CITY OF BLOOMINGTON

PLAN COMMISSION

November 13, 2017 @ 5:30 p.m.
COUNCIL CHAMBERS #115
CITY HALL

**BLOOMINGTON PLAN COMMISSION
STAFF REPORT
Location: 335, 325, 337 S. Walnut St.**

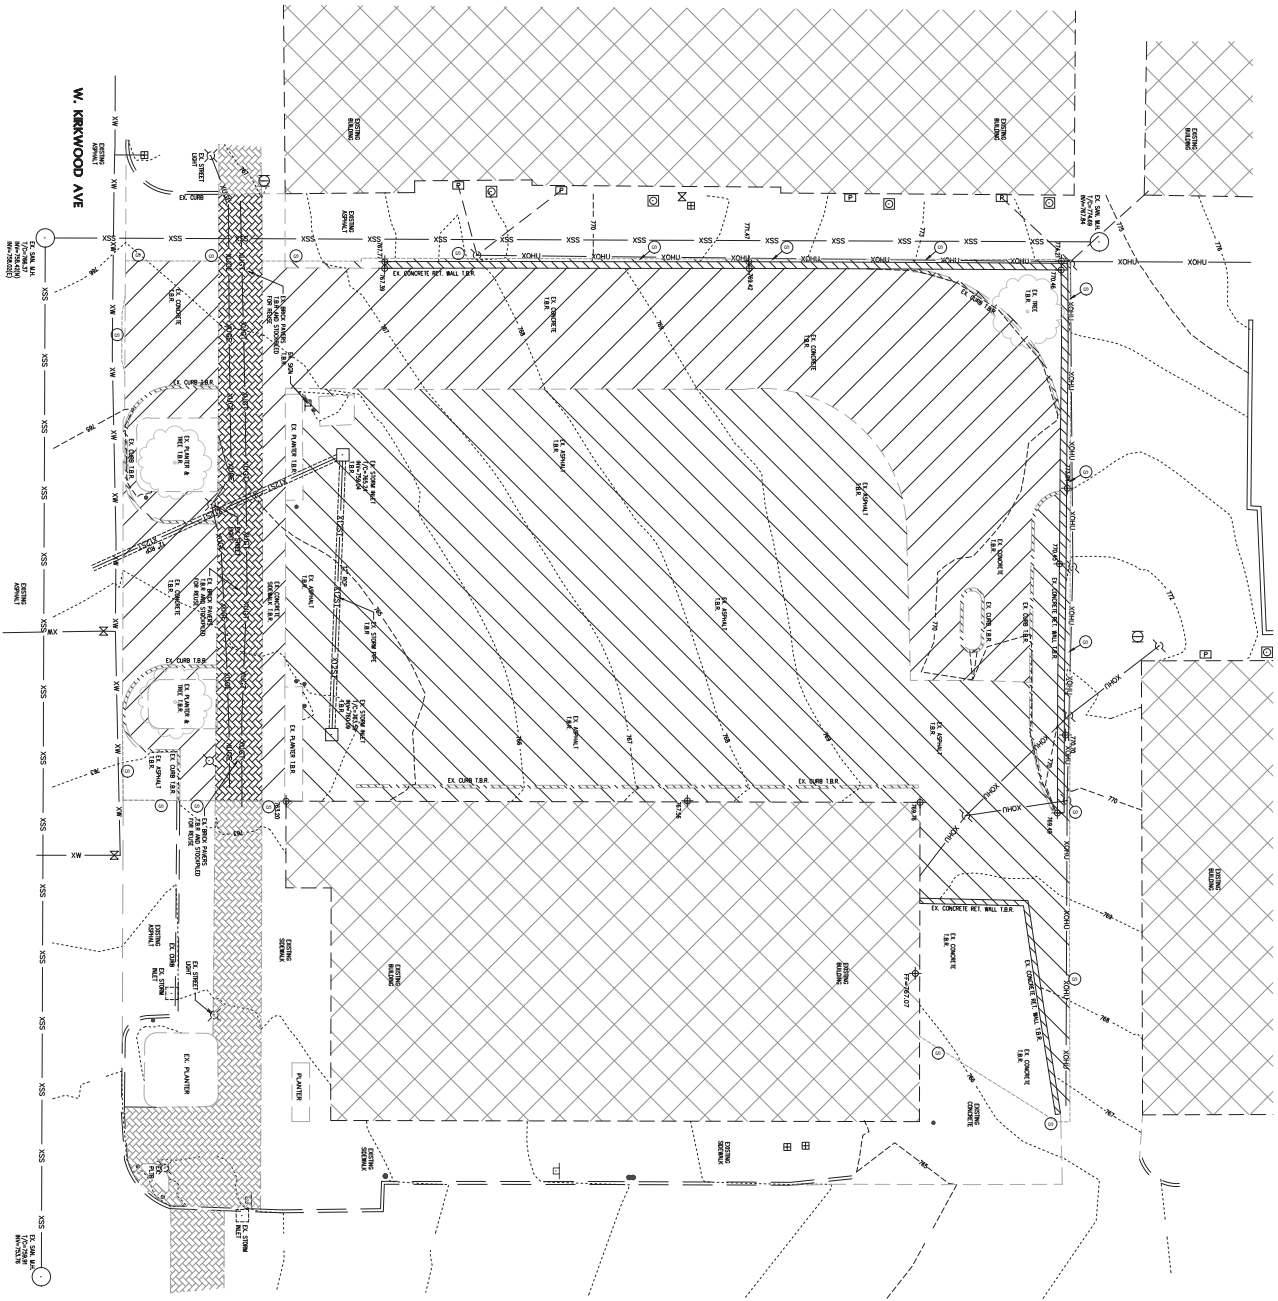
Item #09 The building doesn't appear to meet the modulation requirements. There are 2 distinct modules that appear to be less than 50 feet wide, but the horizontal offset needs to be at least 2'-9".

Answer: The initial submitted design had the modulations offset at 2'-6". The design has been modified with the west module recessed an additional 3" to allow for the required 2'-9" horizontal offset.
